**Nuclear Fuel Services, Inc.**  
P.O. Box 337, MS 123  
Erwin, TN 37650

February 14, 2003

**Subject: Additional Commitments Regarding Licensing of the Uranyl Nitrate Building**

**FIGURE 1: BLEU Complex Site Plan**

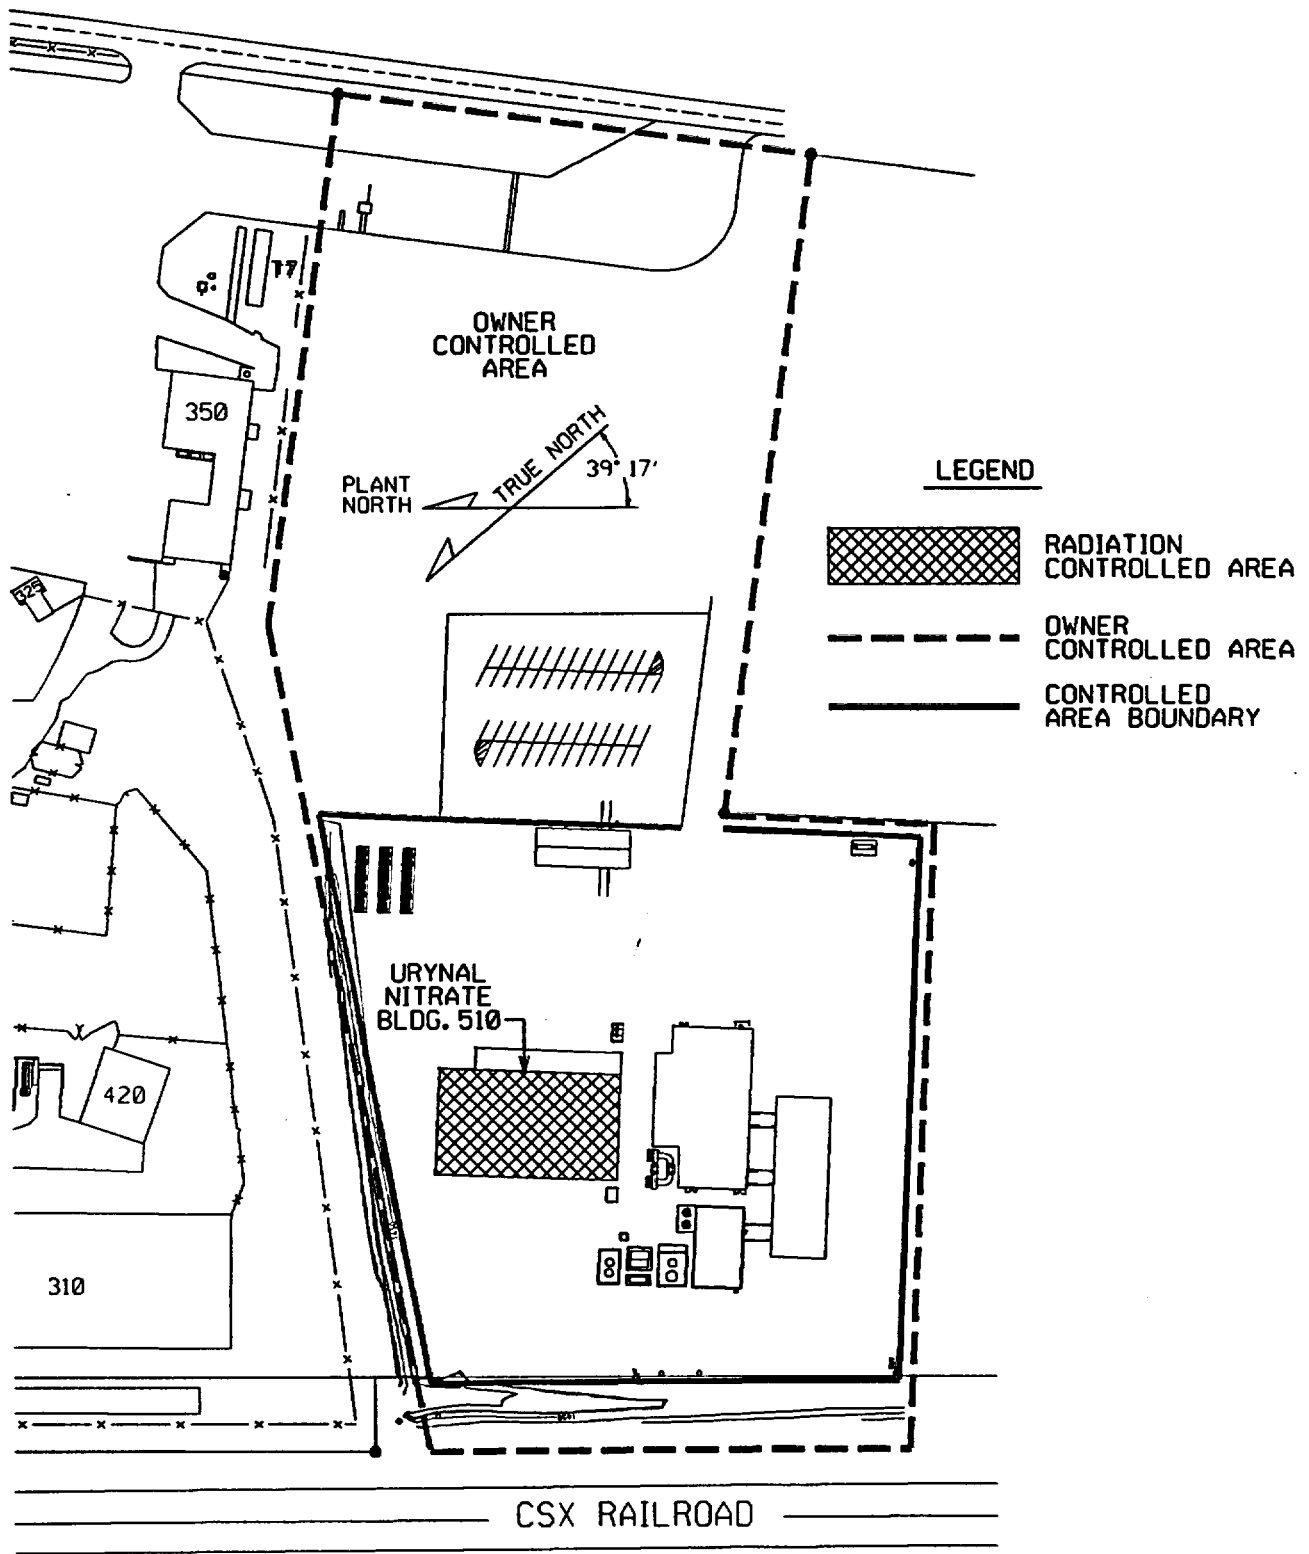
NFS commits to include a revised drawing that identifies the "Controlled Area Boundary" and the "Owner Controlled Area" located at the BLEU Complex. This revised drawing is included in Attachment III. Please note that the "Controlled Area Boundary" (described in 10 CFR 70.65(b)(2)) identified on the site plan is equivalent to a "Restricted Area" as defined in 10 CFR 20.1003 and in Chapter 1, Section 1.7.18, of SNM-124.
